REMARKS

Amendments to the Drawings

FIG.2

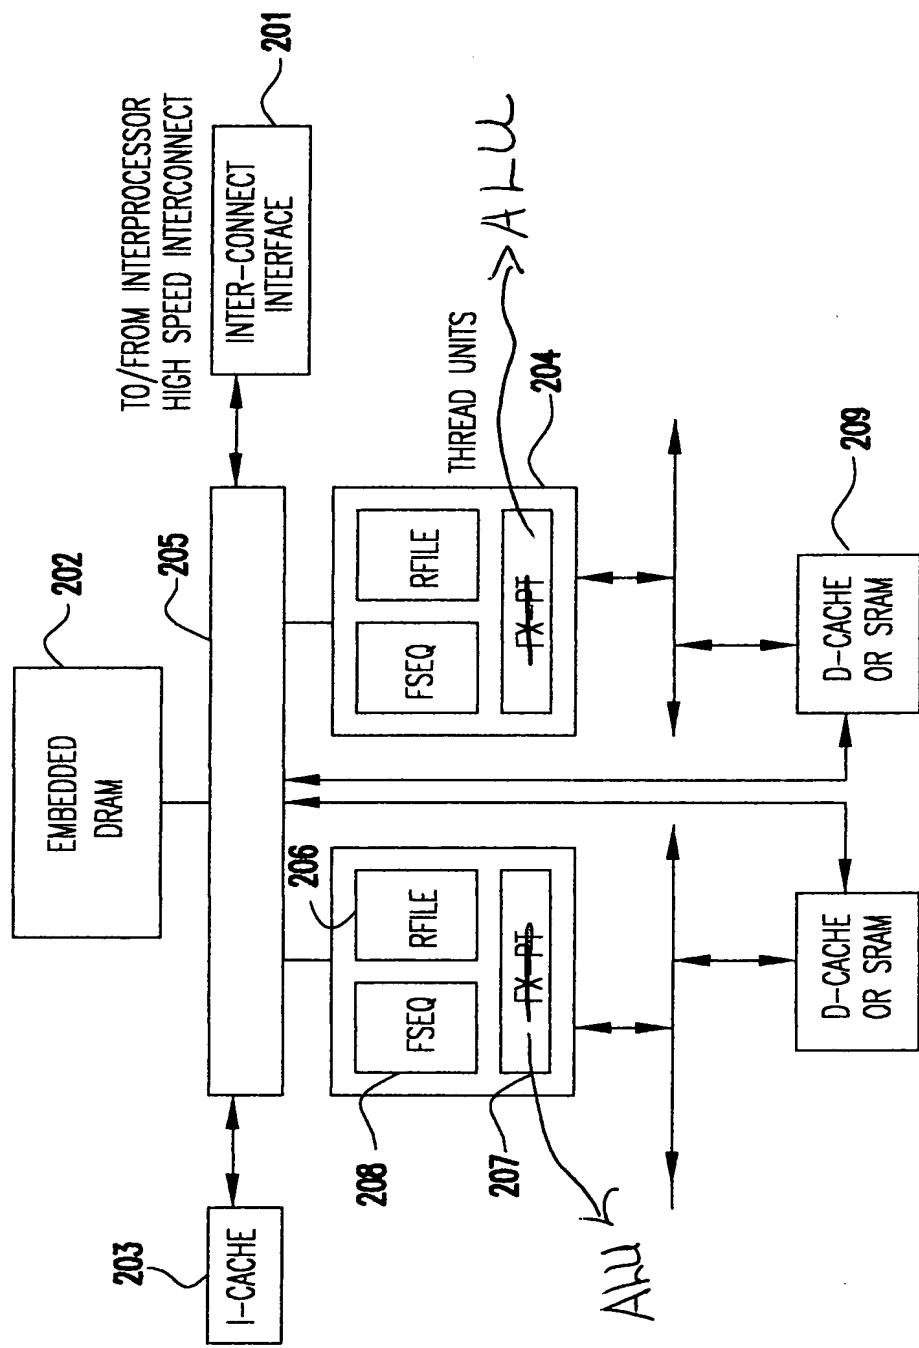
Attached hereto, in connection with Figure 2 of the application, attached is an annotated sheet of Figure 2 and a replacement sheet of Figure 2. The text of item 207
5 has been changed to ALU, as is noted on page 6, line 5 of the patent specification as originally filed. Approval and entry of the replacement sheet in the next action is requested.
